June 27, 2003

ULNRC- 04592

**DOCKET NUMBER 50-483
CALLAWAY PLANT
UNION ELECTRIC COMPANY
PROPOSED REVISION TO TECHNICAL SPECIFICATION 1.1,
"DEFINITIONS"; TECHNICAL SPECIFICATION 3.7.3
"MAIN FEEDWATER ISOLATION VALVES (MFIVs)"; AND
STEAM GENERATOR TUBE RUPTURE WITH OVERFILL RE-ANALYSIS
Reference: ULNRC-04845, dated May 9, 2003 (LER 2003-003-00)**

Feedwater Isolation Valves

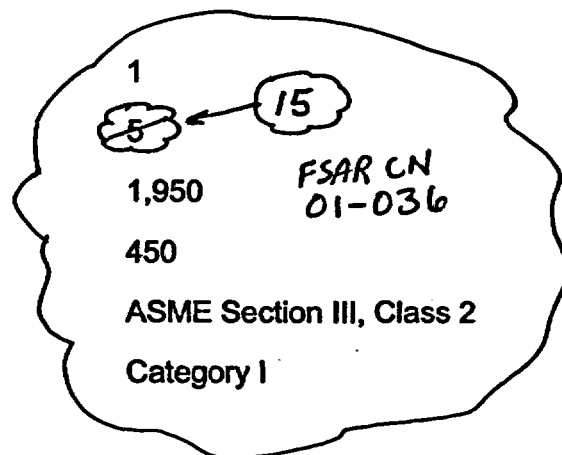
Number per main feedwater line	1
Closing time, sec	5
Body design pressure, psig	1,950
Design temperature, F	450
Design code	ASME Section III, Class 2
Seismic design	Category I

Considering the postulated plant and external conditions, the main feedwater isolation valves are designed and assumed to close in 15 seconds or less upon receipt of an automatic or manual close signal.

Figure 15.6-3.2.e: Ruptured Steam Generator Break Flow Flashing Fraction Transient for SGTR Event with Overfill

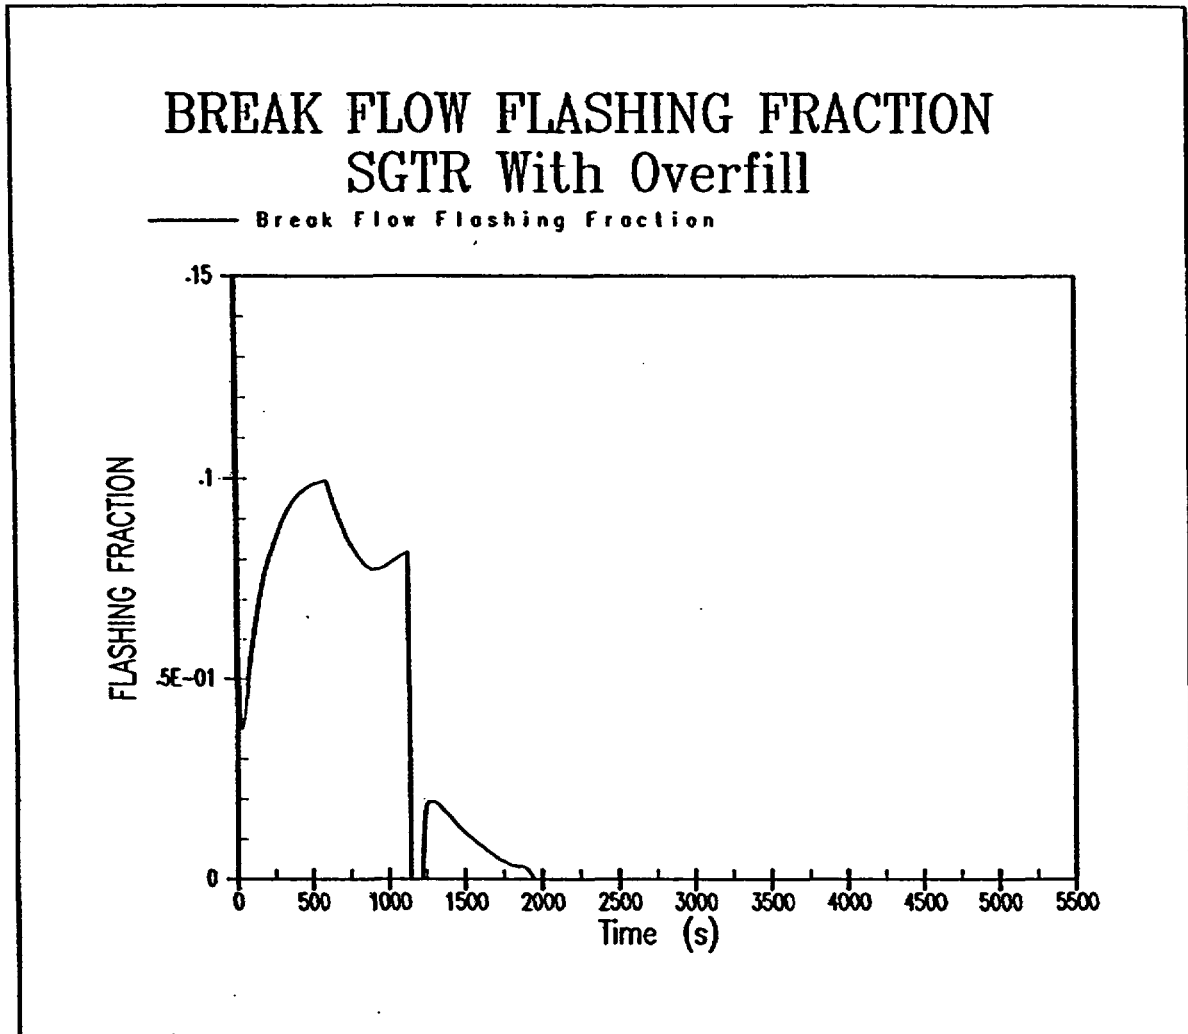
- j. Break flow flashing fraction
 - The Section 15.6.3.1.3 dose analysis modeled conservative bounding values for the flashing fraction. For the analysis of doses for the overfill case the transient flashing fraction from the RETRAN analysis presented in Figure 15.6-3.2.e is used. This is consistent with the analysis approved in Reference 3. This analysis models the release of all the activity contained in the flashed break flow. This conservative assumption is consistent with Section 15.6.3.1.3 which modeled the direct release of activity in flashed break flow even after the ruptured SG's failed open atmospheric relief valve (ARV) was isolated. FSAR CN
03-023
steam dump (ASD) valve

Figure 15.6-3.2.g: Steam Generator Atmospheric Release Flow Rate (Ruptured Generator) Transient for SGTR Event with Overfill

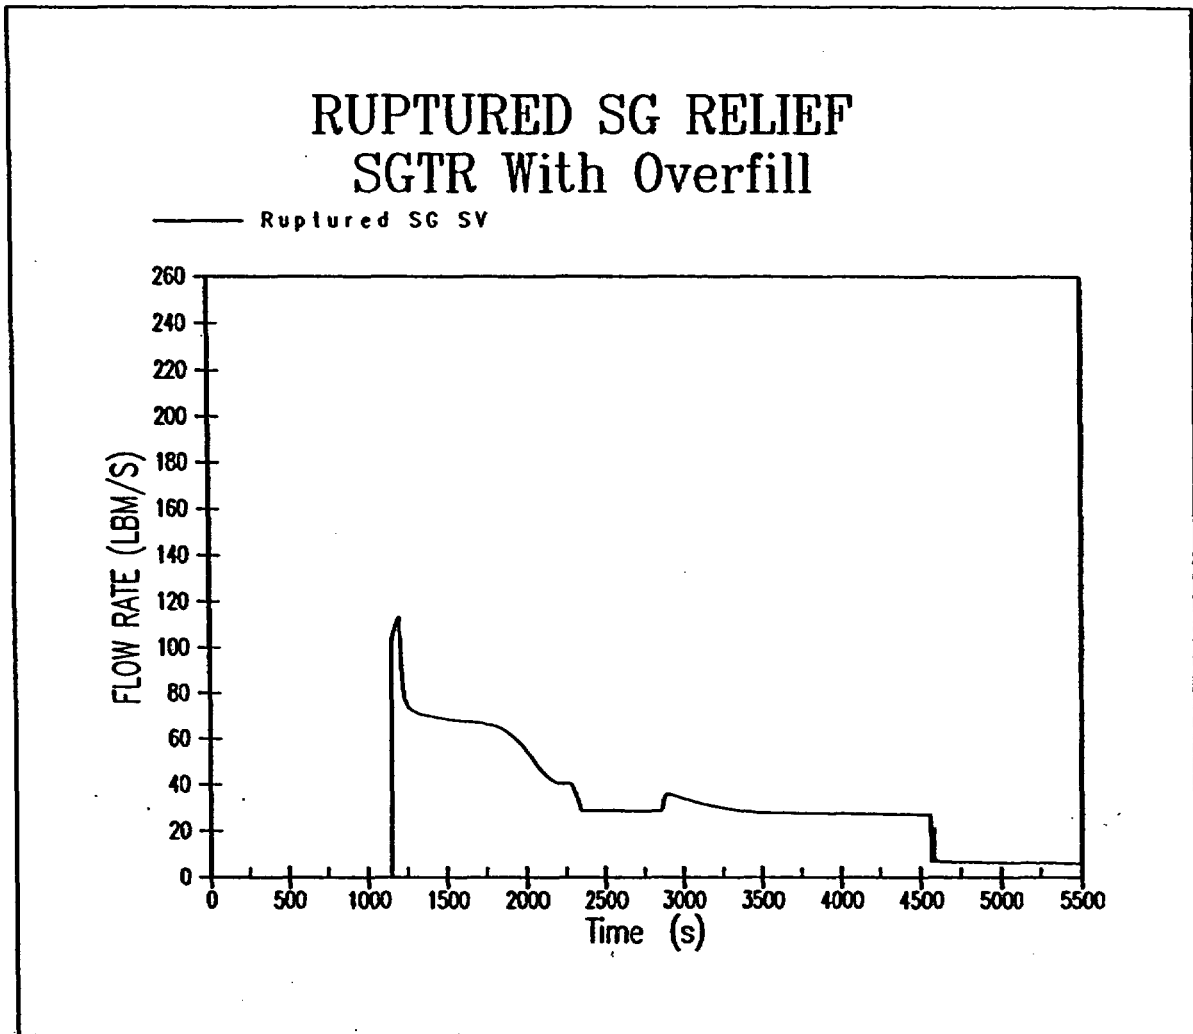
- k. The ruptured SG releases are modeled using the RETRAN analysis results presented in Figure 15.6-3.2.g. In the calculation of doses for the cooldown to RHR conditions it is assumed that a steam flow rate of 8 lbm/sec is maintained due to the failed open safety valve. Thus, 144,000 lbm of steam is released from the ruptured SG in the 5 hours from break flow termination until RHR conditions are reached.

Figure 15.6-3.2.h: Steam Generator Atmospheric Release Flow Rate (Intact Generators) Transient for SGTR Event with Overfill

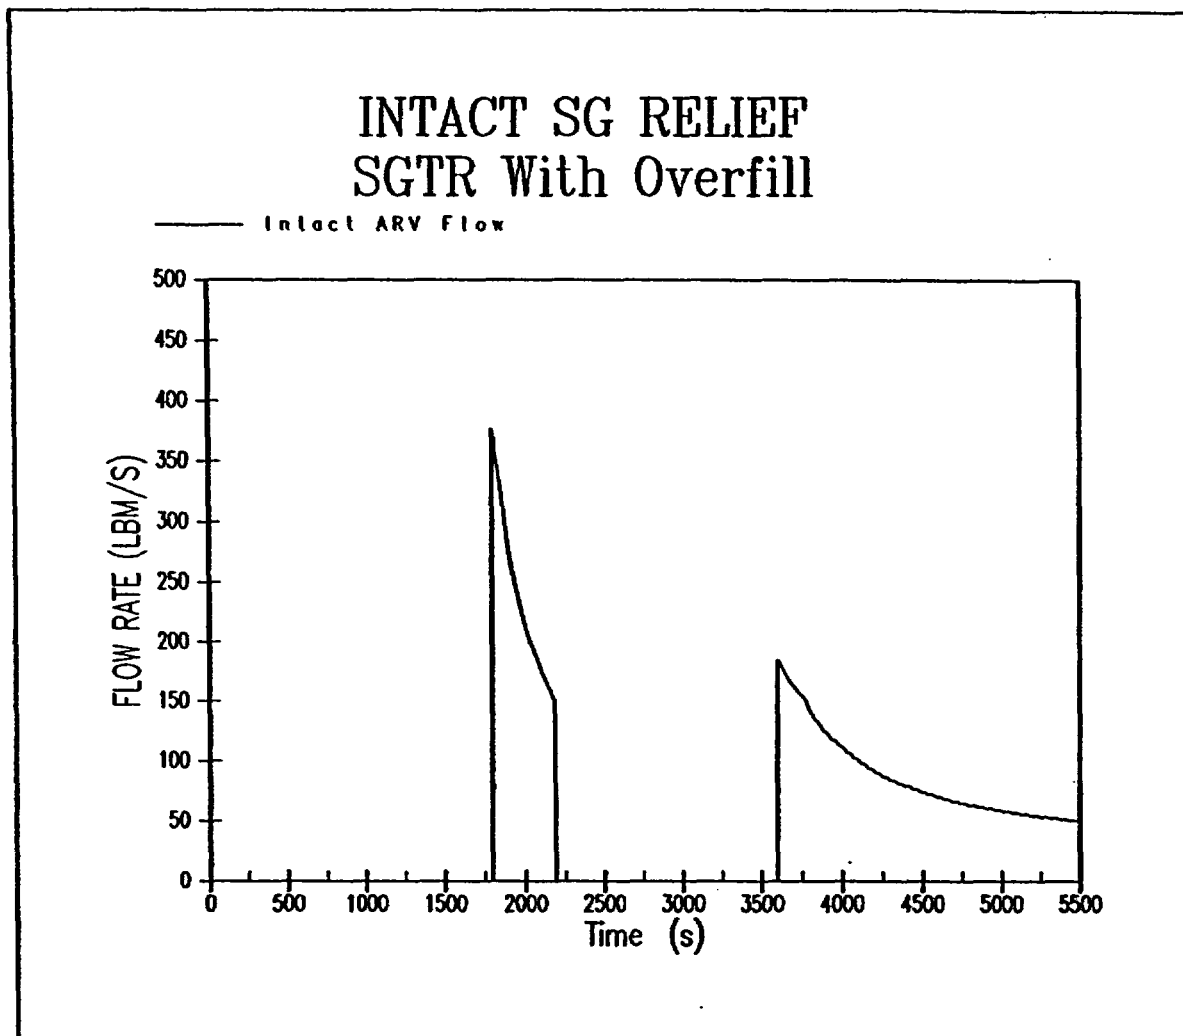
- l. The intact SG releases are modeled using the RETRAN analysis results presented in Figure 15.6-3.2.h. In the calculation of doses for the cooldown to RHR conditions it is assumed that 4000 lbm of steam is released from the intact SGs from the time of break flow termination. This value was conservatively calculated

Figure 15.6-3.2.i: Ruptured Steam Generator Break Flow Rate Transient for SGTR Event with Overfill

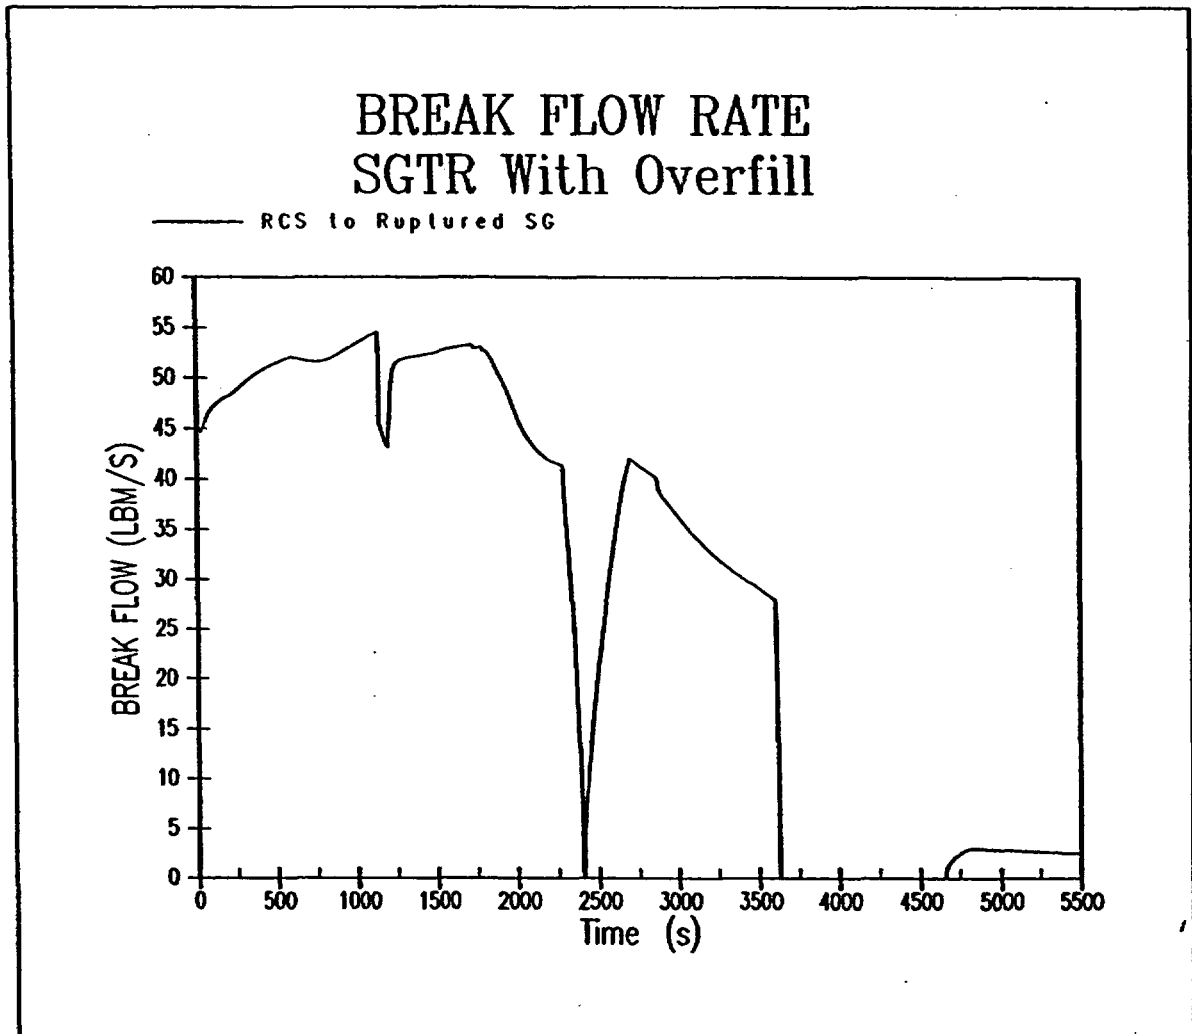
- The Section 15.6.3.1.3 dose analysis conservatively modeled a constant break flow rate. For the analysis of doses for the overfill case the transient break flow rate from the RETRAN analysis presented in Figure 15.6-3.2.i is used, up until the time when water relief stops. This is consistent with the analysis approved in Reference 3.
